The Town of Hilton Head Island Regular Design Review Board Meeting

AGENDA

DESIGN TEAM/ DRB COMMENT SHEET

GILLELAND OFFICE & RETAIL COMPLEX ADDITION
200 CENTRAL AVENUE
LOT # 10 & 11 U.S. HWY 278, A PART OF MAIN ST.
HILTON HEAD PLANTATIONS COMMERCIAL SUBDIVISIONS

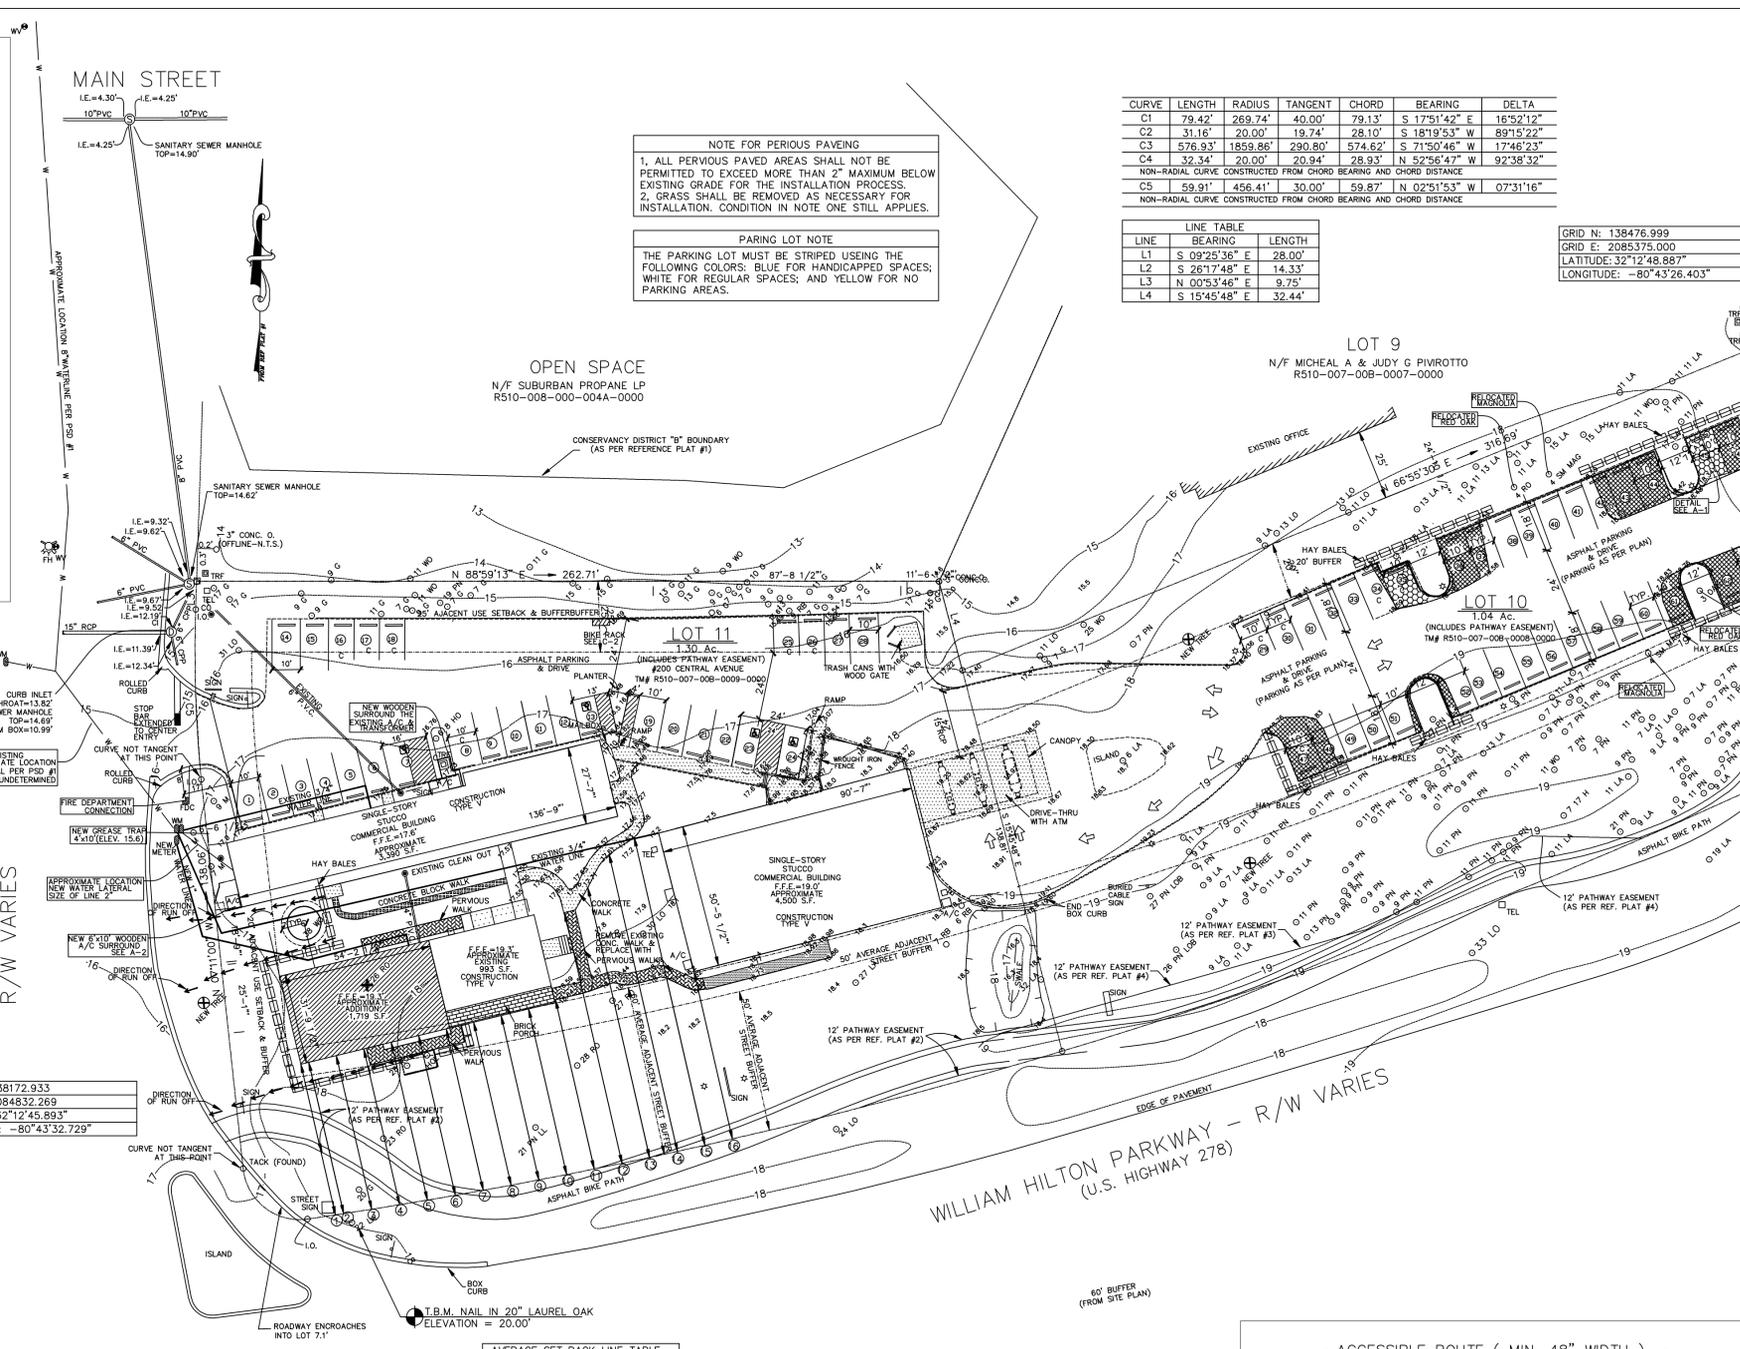
ARCHITECTURAL DESIGN		
The dormers appear to have wood siding on one elevation, and stucco on another, although this could very well be a drawing error, or misinterpretation by Staff. Form, details, materials and colors all match existing structure. Staff recommends approval of the structure, although there are some issues with the buildings site that need to be resolved.		
DESIGN GUIDE/LMO CRITERIA	COMPLIES YES/NO/N/A	COMMENTS OR CONDITIONS
Structure is designed to be appropriate to the neighborhood	Y	
Promotes pedestrian scale and circulation	Y	
Design is unobtrusive and set into the natural environment	Y	
Utilizes natural materials and colors	Y	
Avoids distinctive vernacular styles	Y	
Design is appropriate for its use	Y	
All facades are have equal design characteristics	Y	
Avoids monotonous planes or unrelieved repetition	Y	
Has a strong roof form with enough variety to provide visual interest	Y

LANDSCAPE DESIGN
None submitted. A full landscape plan relative to the new structure will be required for Final Approval.
